Title: Advisory Committee on Reactor Safeguards
AP1000 Reactor Subcommittee Meeting
Open Session

Date: Friday, November 19, 2010

Section 23.W – Changes to Add a Vacuum Relief System to the Containment

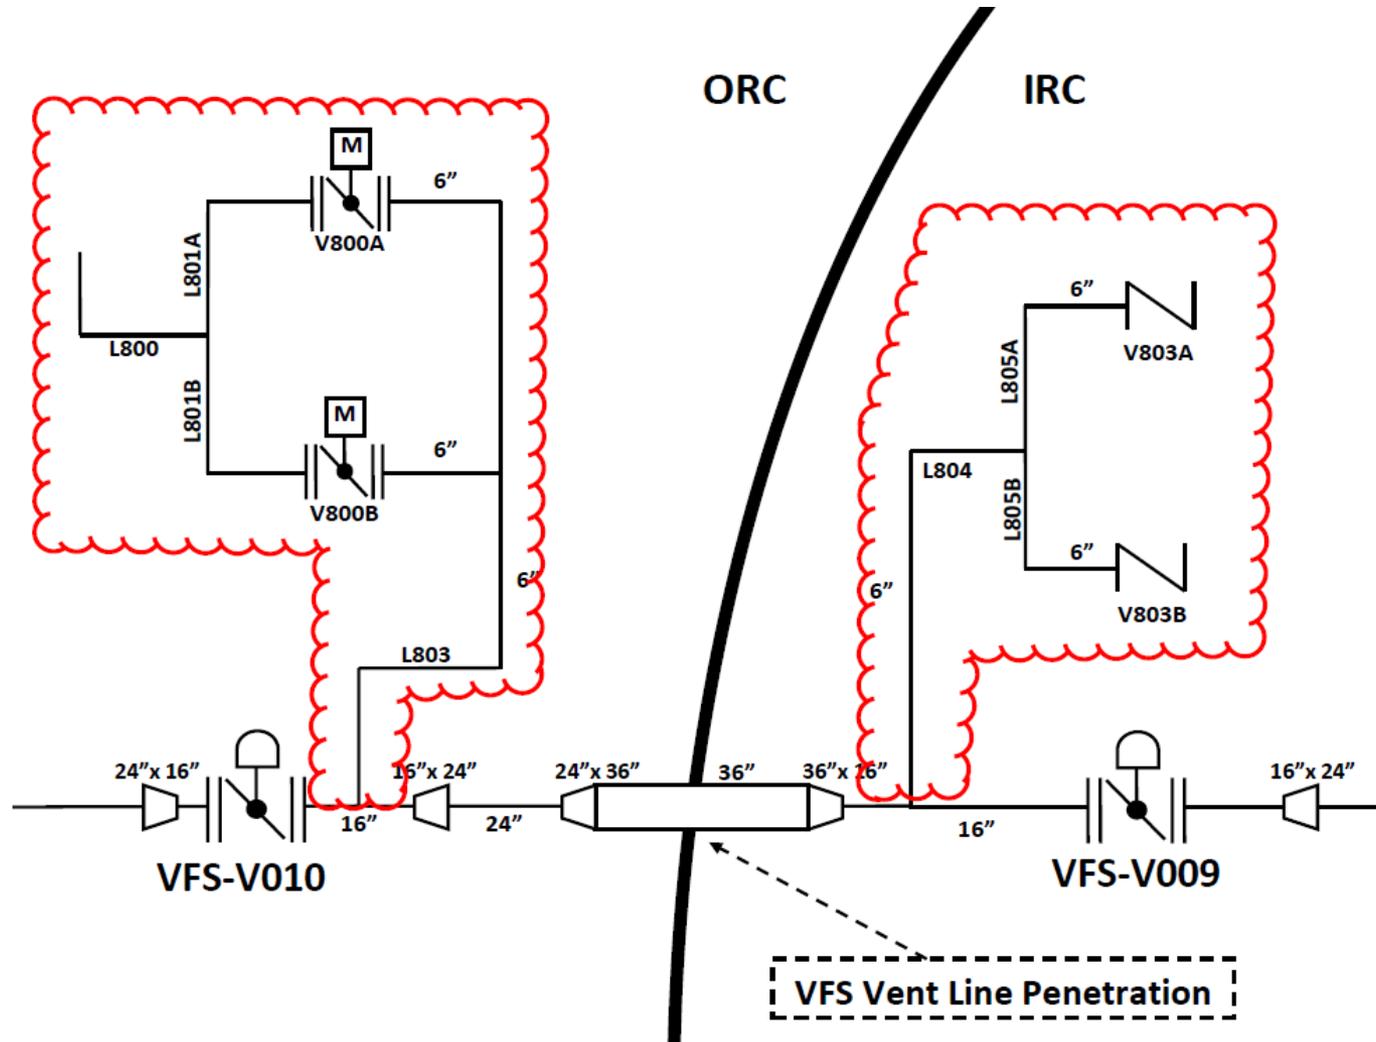
- Proposed design changes
 - Add a vacuum relief system to the containment to prevent external differential pressure between containment and the shield building from exceeding the design value
 - Reduce external pressure design limit from 2.9 psid to 1.7 psid
 - Add Technical Specification 3.6.10, Vacuum Relief Valves, to provide assurance these components will adequately perform their functions.

Vacuum Relief Piping Arrangement

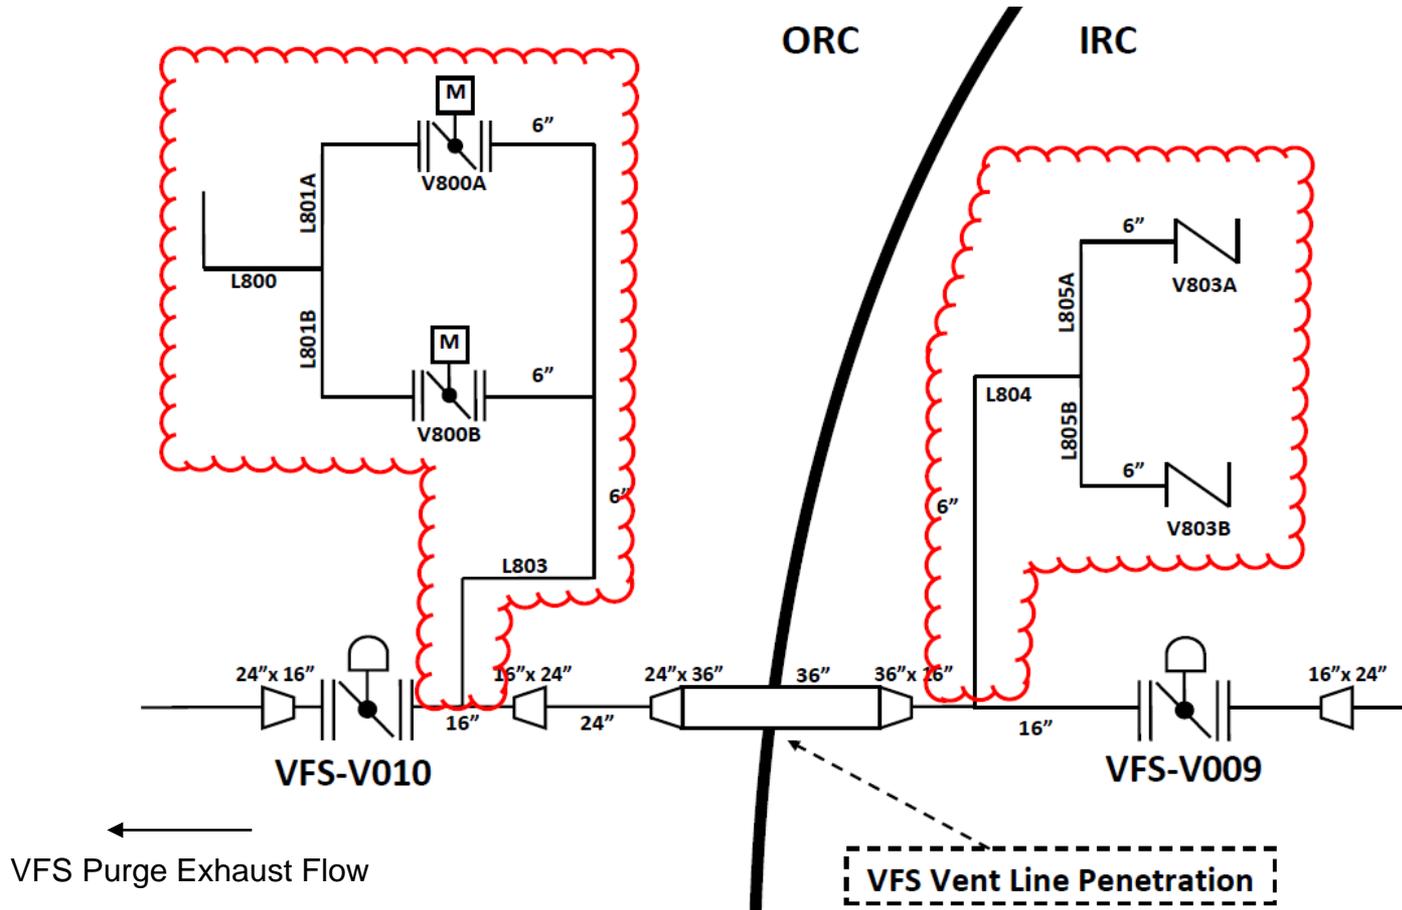
2 This is a diagram that shows a vacuum
3 relief system was added. What I wanted you to do was
4 kind of look at that diagram. And I'll go through the
5 second slide, which is an overview of what the changes
6 were.

7 Fundamentally we added -- using existing
8 purge exhaust penetration, we added outside of
9 containment two parallel butterfly-operated valves and
10 inside containment two parallel check valves that are
11 balanced check valves opened with a slight pressure.

7 We identified a containment over cooling
8 event that required the addition of this system in
9 looking at our design. And, consequently, we added a
10 six-inch vacuum relief-sized system that's shown on
11 the other drawing.

12 The schematic of these meets the ASME
13 section 3 criteria, NE 771.52, for a vacuum relief
14 device for the containment vessel itself. So it's
15 designed to be consistent with that. And, actually,
16 as I'll show you later, it's similar to the
17 configuration of current plants that have the steel
18 shell containment like we do.

23 The arrangement is, as you have seen in
24 the other drawing, two MOV butterfly valves. They're
25 class 1E butterfly valves with an actuation signal to

4 And then the check valves are inside
5 containment. Since these are active valves, they're
6 added to the active valve list, table 39-12. And they
7 have in-service testing appropriate to the active
8 function plus the containment seat leakage
9 requirements for this. So it's no different than any
10 other containment isolation valve.
